SUBJECT: HOLTEC INTERNATIONAL'S APPLICATION FOR SPECIFIC INDEPENDENT
SPENT FUEL STORAGE INSTALLATION LICENSE FOR THE HI-STORE
CONSOLIDATED INTERIM STORAGE FACILITY FOR SPENT NUCLEAR
FUEL – FIRST REQUEST FOR ADDITIONAL INFORMATION, PART 5

First Request for Additional Information, Part 5

Application for specific independent spent fuel storage installation license for the HI-STORE Consolidated Interim Storage Facility in Lea County, New Mexico

Figure 2.1.2: HI-STORE CIS Facility Site Boundaries [2.1.3]

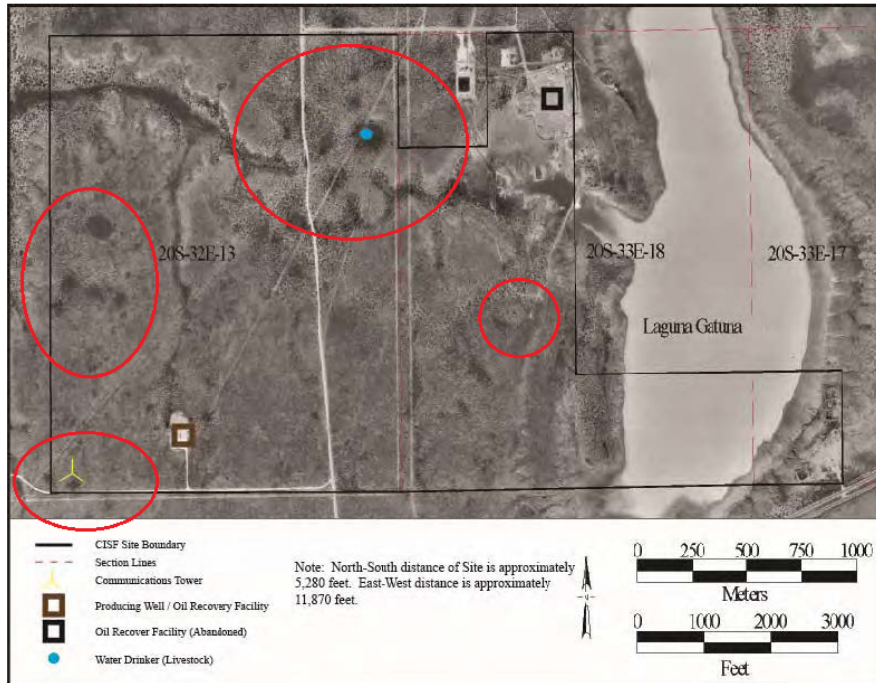
Section 2.2.2 of the SAR, "Pipelines," states that an oil/gas producing well exists at the proposed site. The SAR Figure 2.1.2 also shows a producing well in the southwest corner of the facility.

RAI 2-26: Related to origin of potential dissolution features at the site

Explain the origin of the features circled in red in Figures 2.1.2 and 2.1.5, particularly with respect to dissolution of the Capitan Reef or other subsurface carbonate and evaporite deposits either through natural process or human activities. Also, assess the future potential for similar surface deformation as a result of natural processes or human activities in the site area.

Figure 2.1.5: Aerial View of the Site (Full Build-Out) [2.1.8]

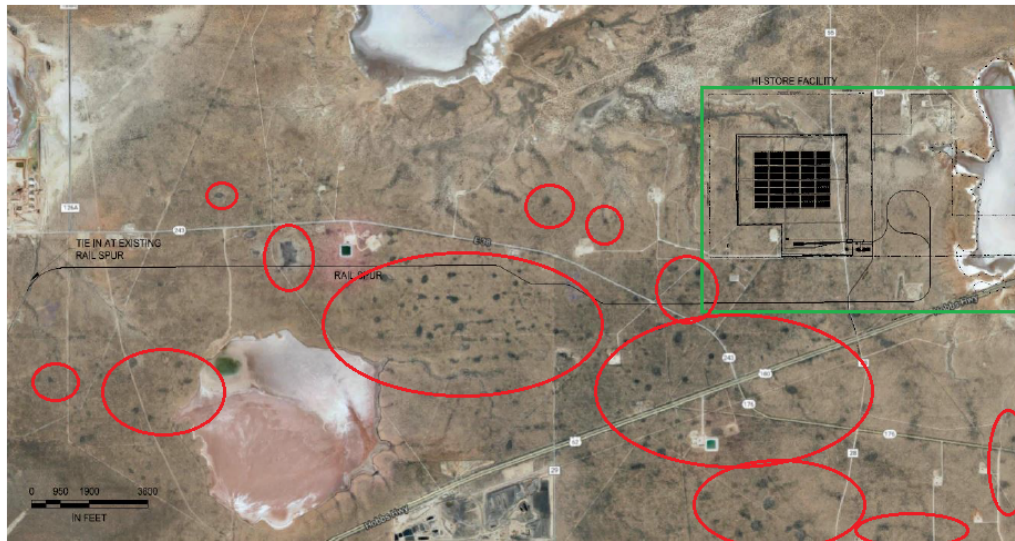
RAI 2-22: Provide additional information describing the proposed rail track and embankment that will connect the proposed CISF with the existing railway spur (SAR Figure 2.1.5). The information should include elevations of railroad embankment, any hydraulic structures incorporated into the embankment, and design parameters of the hydraulic structures if applicable. Also, provide information on the likelihood of failure for the rail track and embankment during extreme weather events, e.g., a PMP, and the effect of such failure to the flooding of proposed CISF on-site structures, systems, and components.

Section 2.1.2 of the SAR stated that “aerial view of the site is shown in Figure 2.1.5 and several plot views of the HI-STORE CIS Facility with all phases complete are shown in Figures 2.1.6(a), (b), and (c).” Figure 2.1.5 of the SAR indicates that a rail track is proposed to connect the proposed CISF to an existing rail spur to the west of the site. Figure 2.1.6(a) of the SAR indicates that the proposed rail track will run between the proposed CISF and Laguna Gatuna but does not provide the elevation of the rail track and any potential hydraulic structure incorporated into the railroad embankment.
